ORDINANCE NO. 17-1-1

An ordinance approving and authorizing the execution of Change Order No. 1 for Parish Project No P160302-1, Road Maintenance 2016, to balance the contract quantities with actual quantities resulting in an increase of \$218,790.12 and a decrease in time of twenty one (21) days.

CHANGE ORDER

Project: P160302-1

Johnson St. , St. Rose, LA 70087

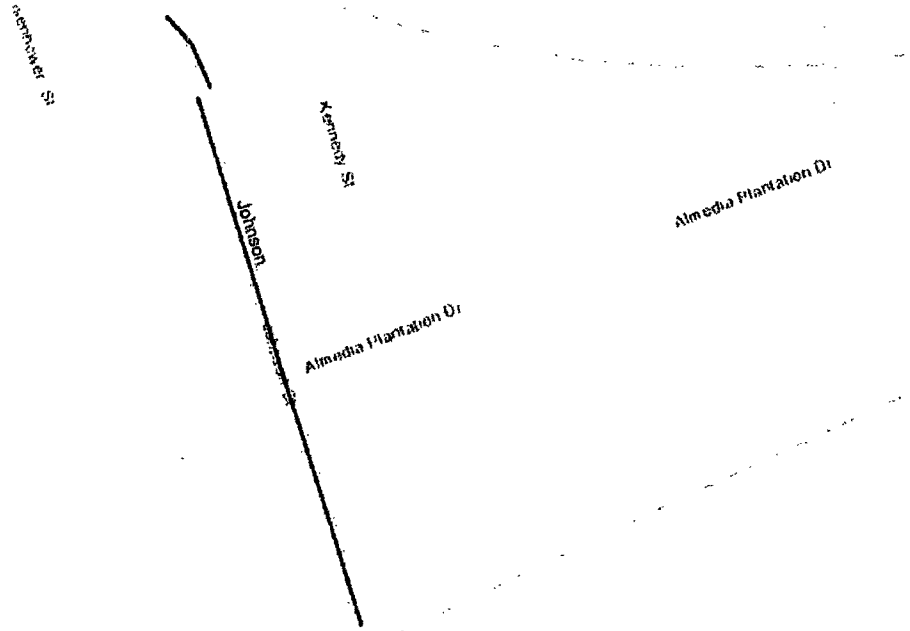
Description: Breaux Ln. was found to be a private street; therefore, it is being removed from the project. The approximate cost savings for not performing work on Breaux is \$12,184.63. Almedia Plantation Dr. and Johnson St. are to be added to the project. Each of these streets will receive patching, mill, overlay, shoulder material, etc. The estimated costs for the additional work are \$49,942.25 for Almedia Plantation Dr. and \$61,101.00 for Johnson St. Mill, overlay, shoulder material, etc. on Kennedy St. will also be added to the project. The estimated cost for the additional work on Kennedy St is \$28,794.50. In addition, a \$7,000 mobilization will be added to the project.

Construction Limits: DEAD END - (ALMEDIA PLANTATION DR.)
